Report 1000635.401
Project No. 1000635.00
20th August 2010

**Level One HRSG Assessment
Consolidated Edison's East River Units 10 and 20**

Consolidated Edison Company of New York
4 Irving Place
New York, New York 10003

Structural Integrity Associates, Inc.
Charlotte, North Carolina

Figure 1 – Plots of DCS historical data for startup on 6/2/10

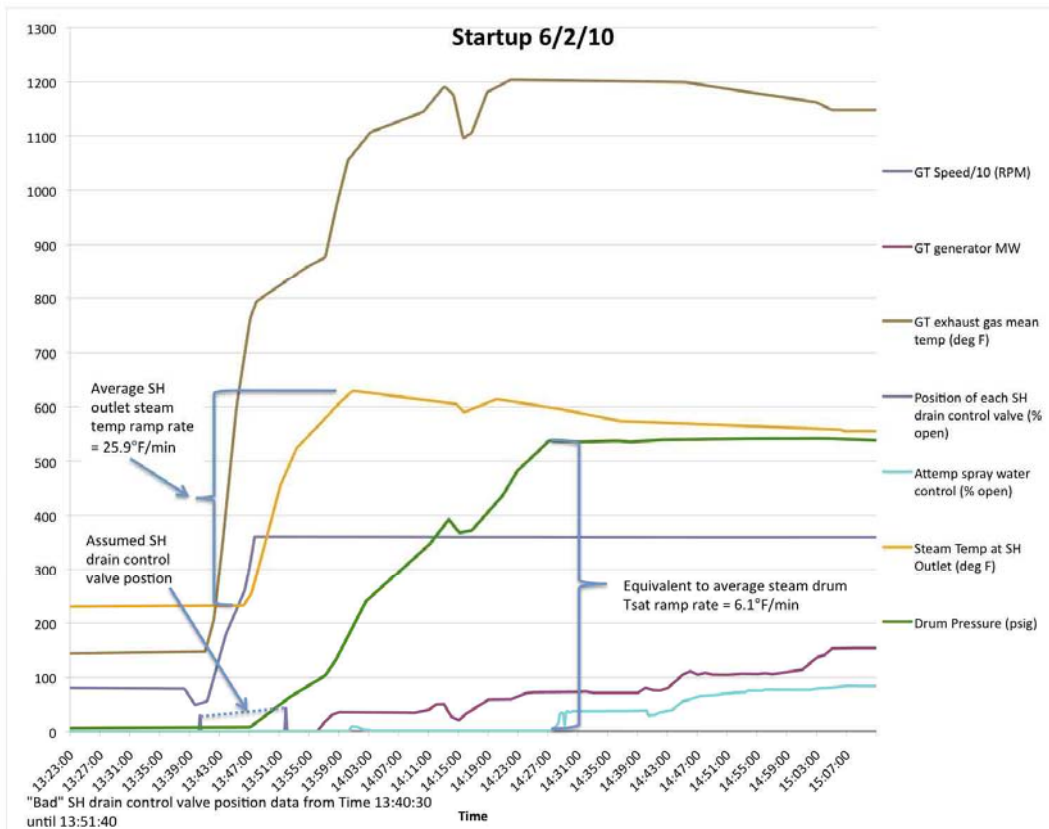
The plot of *Steam Temperature at SH Outlet* during the startup on 6/2/10 in Figure 1 indicates that SH outlet steam temperature increased at an average rate of 25.9°F per minute. During the shutdown on 1/15/10 in Figure 7, the average SH outlet temperature ramp rate was less than -10°F per minute. The SH outlet header thickness is 0.593-inch. For a header of such moderate thickness these heating and cooling ramp rates provide substantial margin against thermal fatigue in the header.

The plot of Drum Pressure during the startup on 6/2/10 in Figure 1 indicates that drum saturation temperature increased at an average rate of 6.1°F per minute. The plant's operating procedures list the maximum permissible drum saturation temperature ramp rate as 20°F per minute. Assuming that the maximum drum saturation temperature ramp rate listed in the operating procedures is consistent with those calculated by the HRSG OEM, the actual ramp rate of 6.1°F per minute observed during the 6/2/10 startup provides substantial margin against thermal fatigue damage to the drum.

Figure 2 – Main steam pipe arrangement with SH outlets, attemperators and existing drains.

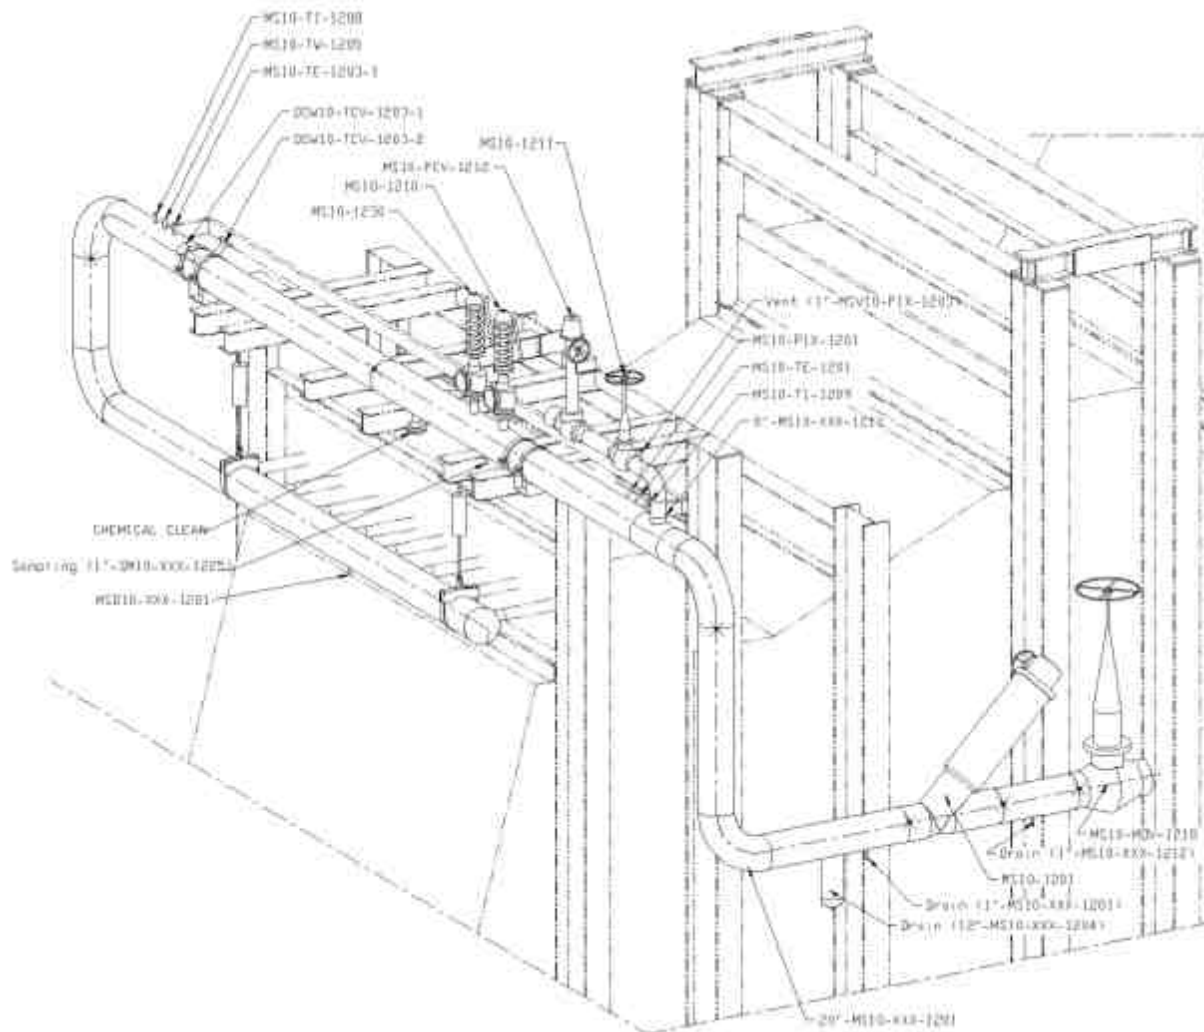
Steam flows from the eight 6-inch SH outlet nozzles into the side of a horizontal 20-inch main steam pipe. A single 1-inch drainpipe with manual valve is located on this pipe at the HRSG centerline. The steam travels up a vertical U-shaped section of 20-inch pipe into another horizontal 20-inch pipe in which the two attemperator nozzles are located at an elevation approximately 10 feet above the SH outlet. A 12-inch drip leg with a 1-inch drainpipe is located on the main steam pipe downstream of the attemperators at an elevation about 14 feet below the attemperators. See Figure 2. Any spray water introduced by the attemperator via valve leakage or inappropriate operation during low, or zero, steam flow conditions is likely to flow back into the SH. Since attemperator leakage and inappropriate operation are not planned events, the single 1-inch manual drain upstream of the attemperator is of no value in preventing backflow of water into the SH. A number of ductile overload and tube fracture events have occurred in other units that lack adequate attemperator piping drains.

To minimize the risk of such failures it is suggested that a 12-inch drip leg be installed in the main steam piping just upstream of the attemperators. Sizing of the drainpipe attached to this drip leg should take into account the maximum attemperator spray water flow anticipated during a worst-case leak or inappropriate operation event. While ConEd is under no obligation to retroactively comply, it is worth noting that the ASME Boiler and Pressure Vessel Code was amended in 2007 to require on new units a low point drain between the attemperator and SH where the risk of back-flow exists.

Figure 3 – Plots of DCS historical data for startup on 6/2/10

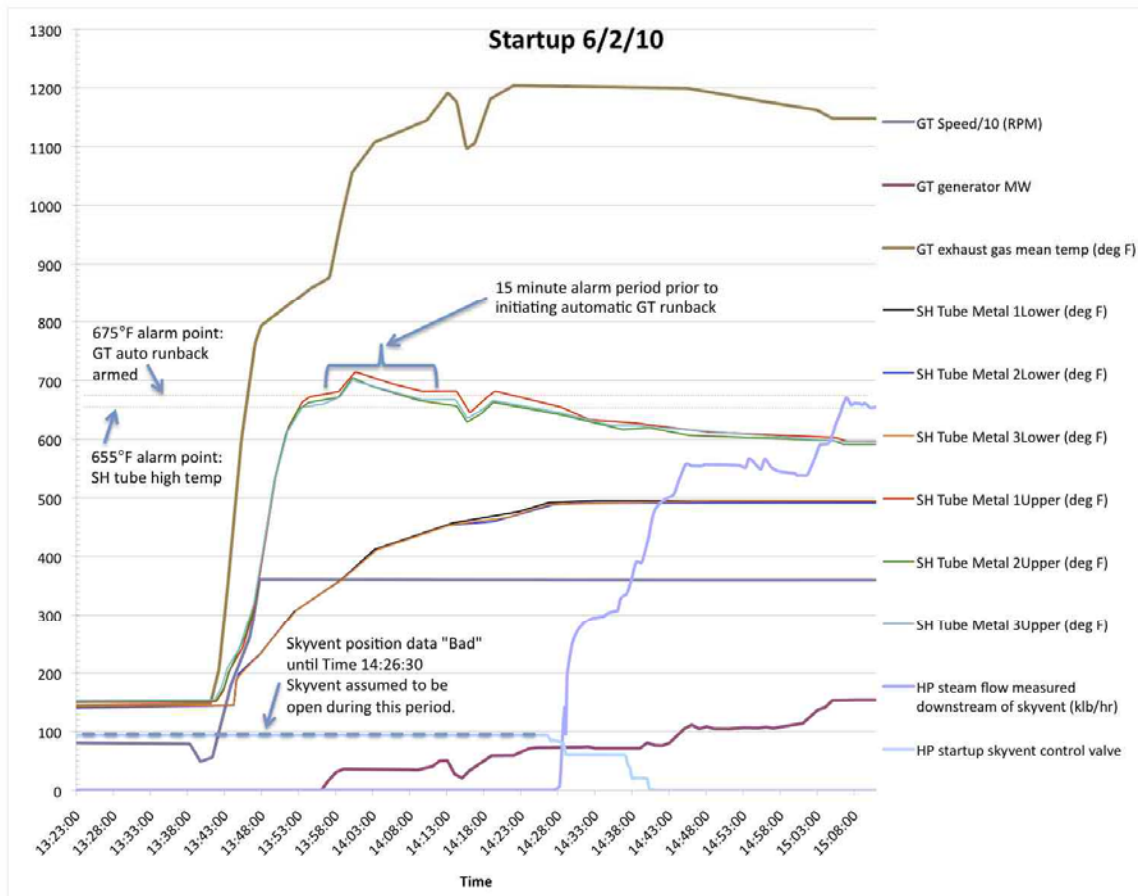
The plots of upper tube temperatures during the startup on 6/2/10 in Figure 3 indicate that during this startup event both the 655°F High temperature and the 675°F High-High temperature alarm points were exceeded and that the High-High tube temperature condition persisted beyond the 15-minute time delay required to initiate a GT load runback. The hottest instrumented SH tube reached a peak temperature of 714°F.

It was reported during the site visit that the runback is triggered if the operator increases GT load too rapidly during startup. While it is apparent from Figure 3 that this protective feature worked as designed during this startup, it would be prudent to determine the optimum GT loading rates, GT load hold points, GT load hold durations, and SH steam flows required during startup to avoid triggering high SH temperature alarms and GT load runback. Once established, these parameters should be incorporated into the plant's written startup procedures and consistently observed. Consideration might also be given to automating these aspects of startup via their incorporation into the plant's DCS logic.

Figure 4 – Plots of DCS historical data for startup on 6/2/10

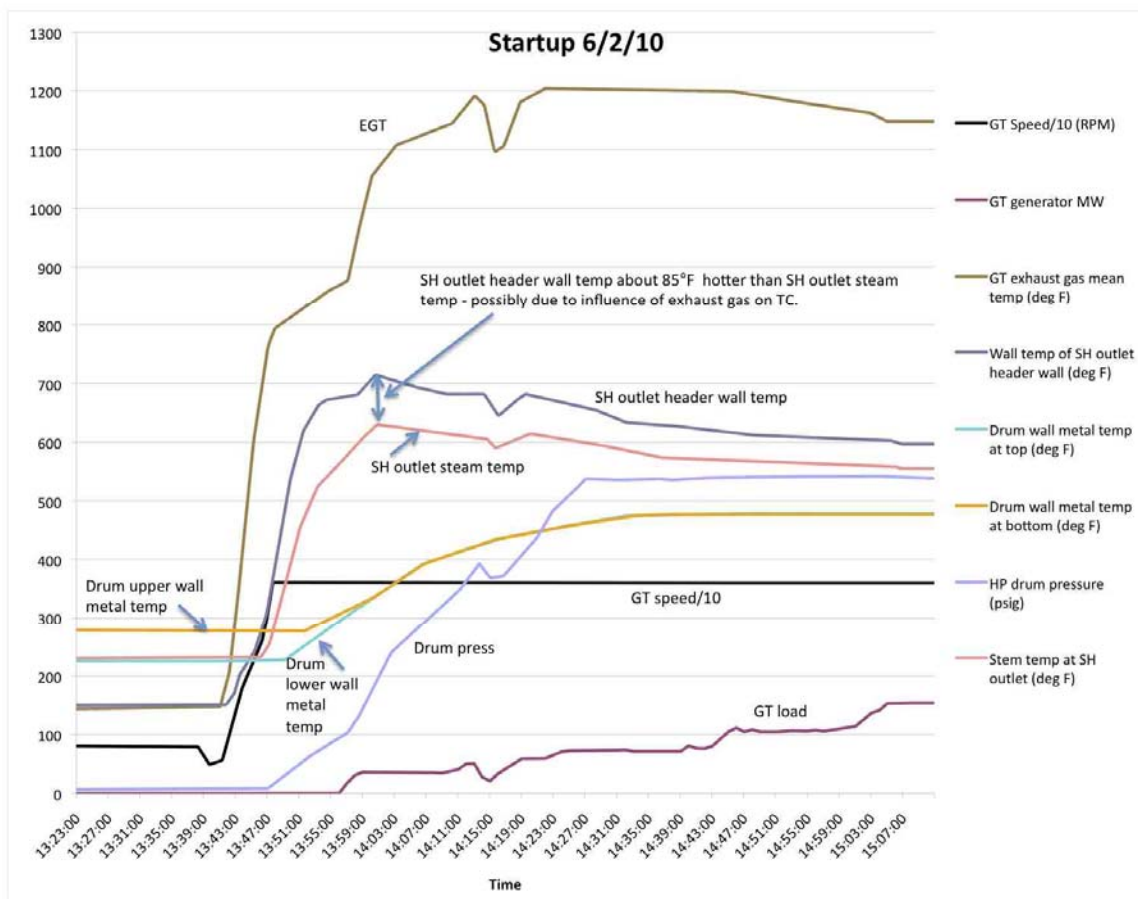
Figure 4 illustrates that the SH outlet header wall temperature is consistently close to that measured at the upper outer surface of the three SH tubes plotted in Figure 3. The header wall temperature plotted in Figure 4 and the SH upper tube temperatures in Figure 3 are consistently hotter than measured SH outlet steam temperature also plotted in Figure 4. The header wall temperature peaks at 714°F, as do the instrumented SH tubes discussed above. While at this peak temperature the header wall is approximately 85°F hotter than SH outlet steam temperature.

It is suggested that the SH header wall thermocouple should be inspected for any of the following conditions that may cause erroneously high readings:

Consider performing replication of the SH outlet headers' outer surface to determine if any metallurgical degradation associated with high temperatures has occurred, particularly if the foregoing thermocouple and gas baffle inspections indicate that the header surface temperatures presented in Figures 4 and 5 are accurate.

Figure 5 – Plots of DCS historical data during high-low-high GT load transition on 5/23/10

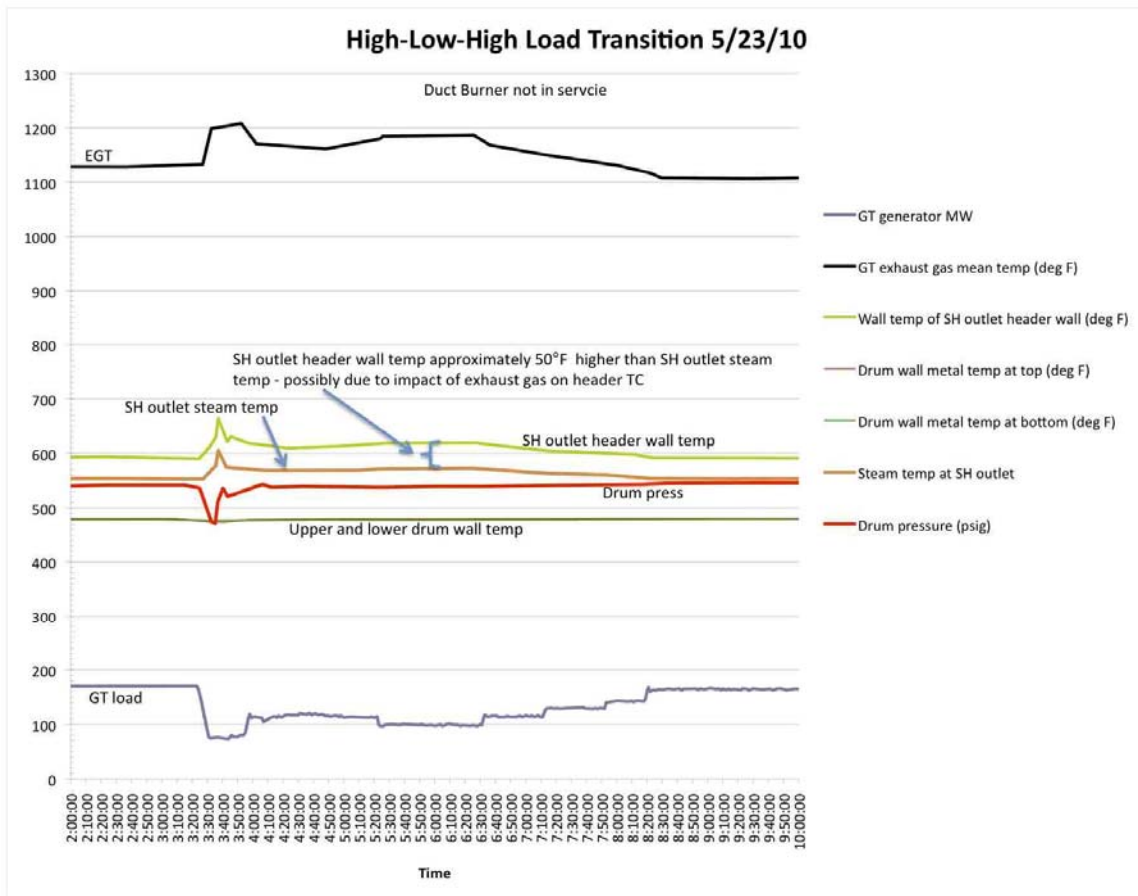
The plot of *SH Outlet Header Wall Temperature* during operation at higher GT load on 5/23/10 in Figure 5 indicates that the header wall temperature is consistently about 50°F hotter than SH outlet steam temperature during stable operation at GT loads above about 80MW. However, during the load reduction transient in Figure 5 the header wall temperature peaks briefly at 664°F, which is above the 655°F High SH tube temperature alarm point.

Figure 6 – Plots of DCS historical data during high-low-high GT load transition on 5/23/10

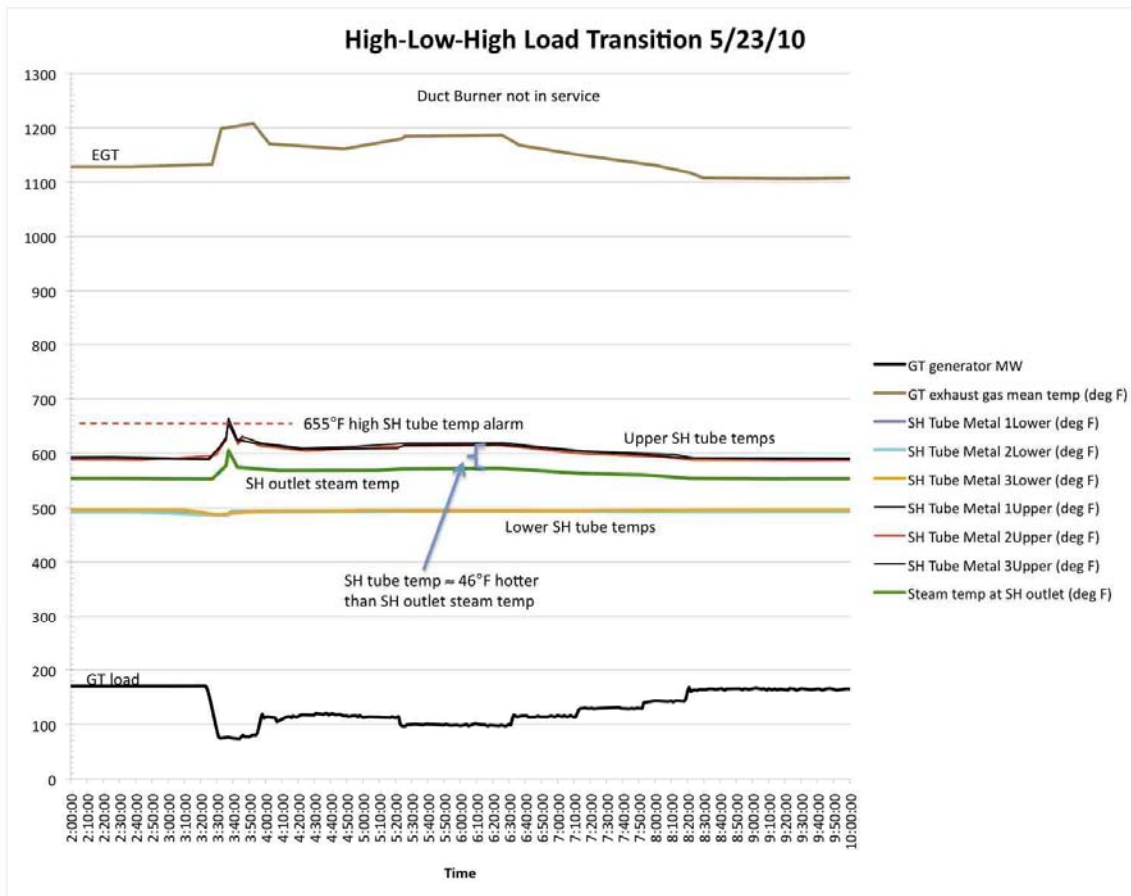
The plots of *SH Tube Metal Temperature* during the GT load transitions on 5/23/10 in Figure 6 indicate that upper tube metal temperatures are consistently about 46°F hotter than SH outlet steam temperature during both high and low GT loads. The hottest tube temperature peaks at 664°F during the load reduction transient, which is above the 655°F High SH tube temperature alarm point. If tube thermocouples are properly insulated to protect them from exhaust gas impingement, during periods of high steam flow rates they should perhaps indicate tube temperatures closer to the temperature of the steam flowing through the tube.

During the GT load reduction in Figure 6 GT load was lowered rapidly to about 73 MW. This load is the GE7FA GT’s “hot zone” and results in exhaust temperature near the maximum (called the isotherm) in excess of 1200°F. When GT load was later increased slightly above 100 MW (presumably to clear the SH tube high temperature alarm) exhaust gas temperature and SH tube temperatures returned to values acceptable for longterm operation.

It is suggested that the SH tube temperature thermocouples are inspected for any of the following conditions that may cause erroneously high readings:

Consider performing replication of the outer surface near the top end of the hottest running SH tube instrumented with a permanent metal temperature thermocouple to determine if any material property degradation associated with high temperatures has occurred, particularly if the foregoing inspections indicate that the tube metal temperatures presented in Figures 3 and 6 are accurate.

It is suggested that transitions from high to low GT loads be conducted in a manner that avoids lowering GT load into the "hot zone" (typically below about 100MW). Some operators of the GE7FA GT who wish to operate below 100 MW have installed an optional GE control package called OPFLEX. In some cases OPFLEX is reported to lower the isotherm temperature by about up to 25°F to 30°F during startup and low load operation. It was reported during the assessment that the East River Units 10 and 20 are equipped with OPFLEX. GE has stated in the past that OPFLEX installations are customized to the particular unit and do not necessarily utilize the same features. It is suggested that ConEd consult GE to determine if the existing OPFLEX version already utilizes the isotherm reduction feature, and if this feature can be added if not already installed.

Figure 7 – Plots of DCS historical data during shutdown on 1/15/10

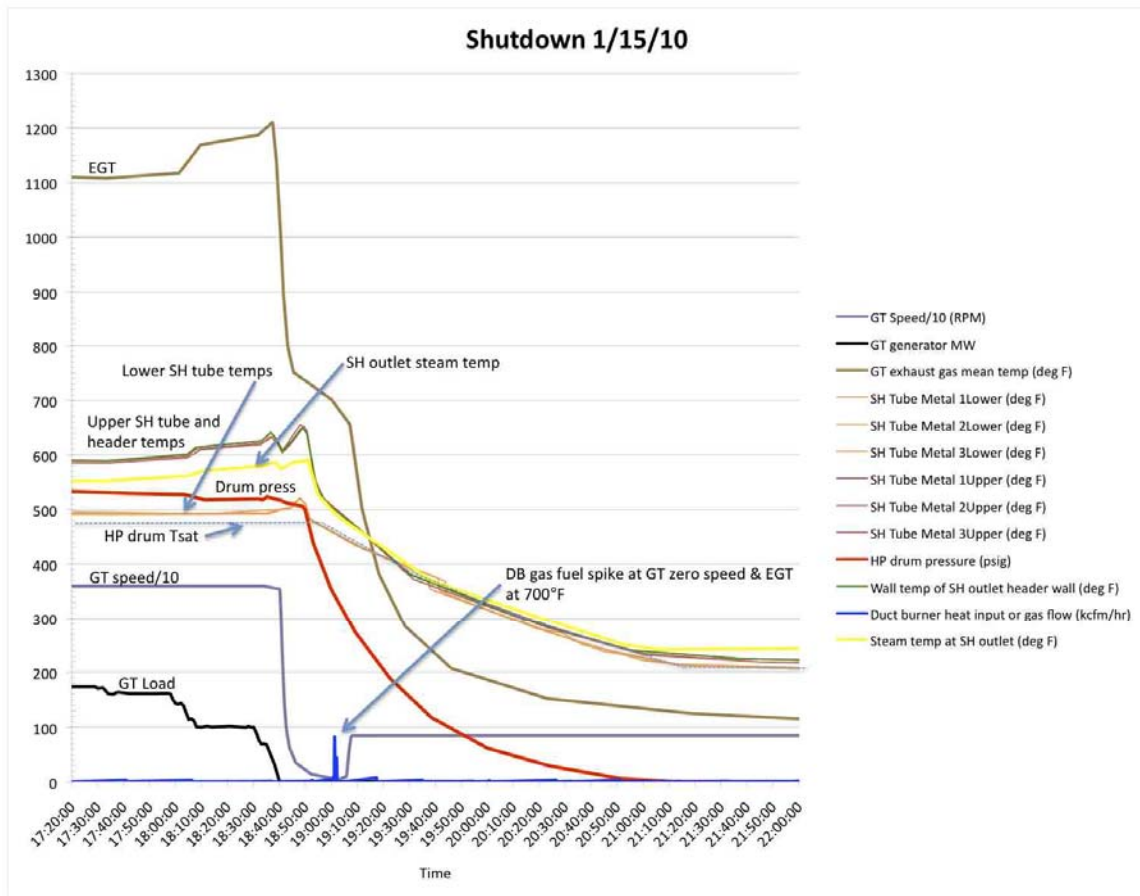
The DCS historical data plots during the shutdown on 1/15/10 in Figure 7 show a spike increase in *Duct Burner Fuel Flow* after the GT has coasted to near zero speed and while exhaust temperature is about 700°F. Soon after forced cooling of the HRSG was initiated via unfired high speed cranking of the GT. It was reported that this spike is the result of depressurizing the duct burner fuel system in preparation for HRSG entry.

The indicated gas path temperature in Figure 7 at the time of the duct burner fuel spike is well below the published auto ignition temperature of natural gas (1076°F). However, it is suggested that yet more margin of safety between auto ignition temperature and gas path components could be attained if the duct burner fuel release were delayed until well into the time period the GT is intended to perform high speed unfired cranking, but also a reasonable period before cranking is suspended.

Figure 8 – Plots of DCS historical data during duct burner light off on 2/3/10

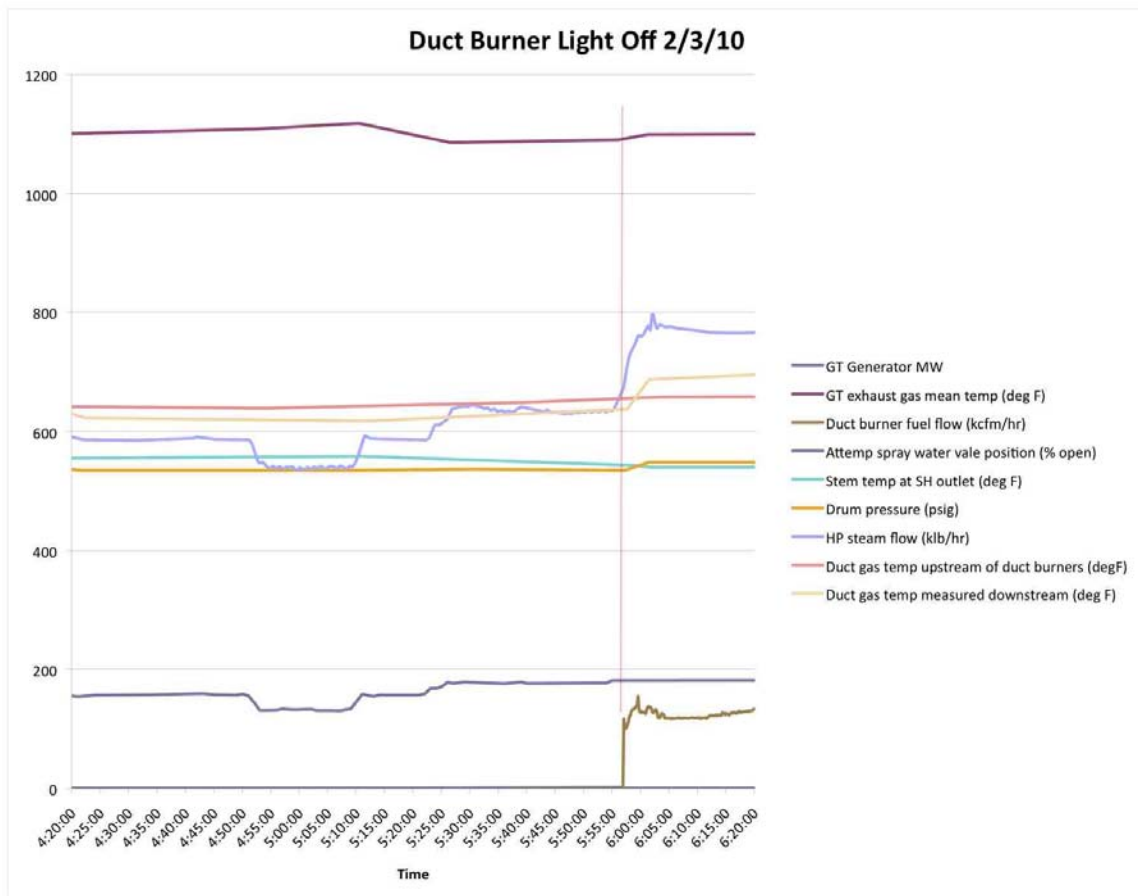
If overly aggressive initial firing rates are used when large duct burners are placed in service and/or overly aggressive firing rate increases occur, then excessive heat input to down stream evaporator tubes can result in abnormally rapid waterside deposit formation. This is due to a significant time delay between application of additional evaporator heat input and increase in evaporator circulation rate. Review of DCS historical data plots during the duct burner light off in Figure 8 and duct burner load
